Re: Catawba Nuclear Station
Docket Nos. 50-413 and 50-414

Section 8.4.7 of the Catawba Safety Evaluation Report discusses Confirmatory Item 36, Flooding of Electrical Equipment as a Result of a LOCA. In response to this item, please find attached a revised response to FSAR question 440.48.

Figure Q440.48-1
Rev. 8

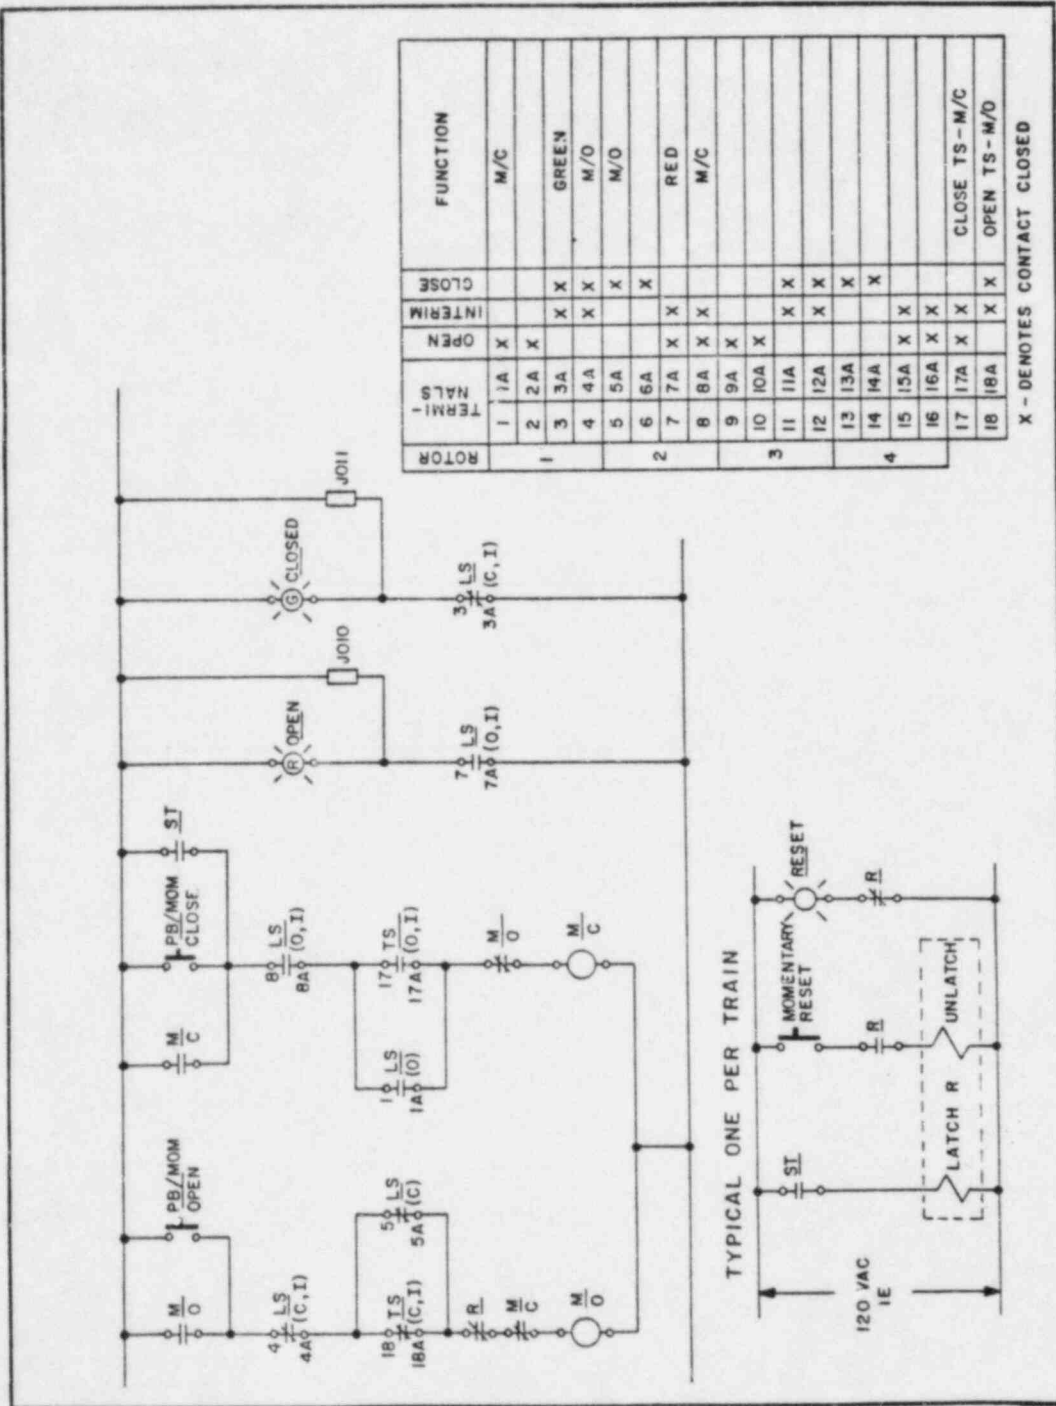
In addition, 18 valve operators were not previously qualified for submergence (1KC429B, 1NC54A, 1NI95A, 1NI266A, 1NI267A, 1NM6A, 1NM72B, 1NM75B, 1NM78B, 1NM81B, 1NM187A, 1NM190A, 1NM197B, 1NM200B, 1NM207A, 1NM210A, 1NM217B, and 1NM220B).

These valves close on Containment Isolation Phase A (ST) signals. There is sufficient time for them to close before being flooded. To prevent possible repositioning after flooding, the valves motor controls circuits are being modified (see Fig. Q440.48-1). One relay per train will be energized by a ST signal and mechanically latched in. Normally closed contacts from this relay will be wired between the limit switches and the open motor starter coils of valves of the corresponding train. These contacts will open on ST and prevent any spurious limit switch operation from repositioning the valves. These relays will have manual reset capability in the control room.

Breakers and fuses are coordinated such that, in the case of faults caused by submergence, the faulted valve circuits will be isolated without adversely affecting the upstream class 1E power sources. These modifications will be completed prior to fuel loading.
